## Cobra Motorcycle Mfg.

## TSB0710: Clutch washer, bolt, & arbor

December 14, 2009

Figure 1

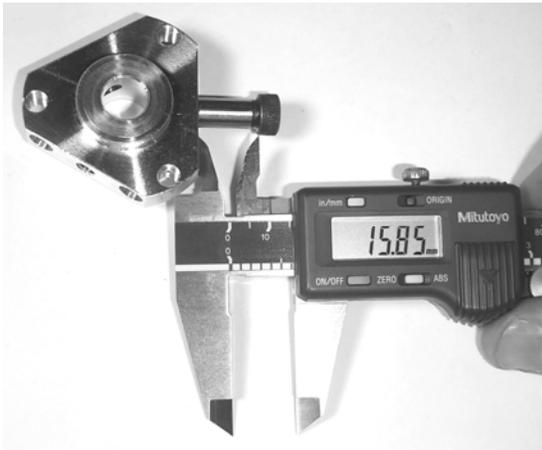
- 1) Amount of wear on shoes (this is difficult to measure and can only be approximated by the step in the shoe where it rides outside the basket – new shoes will not have one, old shoes will have a large one).
- 2) Effective length of the shoulder on the clutch arbor bolt (see figure 1). Nominal is 15.85mm (0.624"). As this decreases, the spring stack needs to decrease equally. This can change due to the shoulder bolt 'setting' into the arbor (see figure 2)

If your effective shoulder length is off, or your shoes are worn, adjust the height of your overall combined spring stack accordingly (i.e. if your effective shoulder length is 0.5mm short of the 15.85 measurement, decrease the overall combined spring stack height by 0.5mm, or if your shoes are worn by 0.5 mm, increase the overall combined spring stack height by 0.5mm).
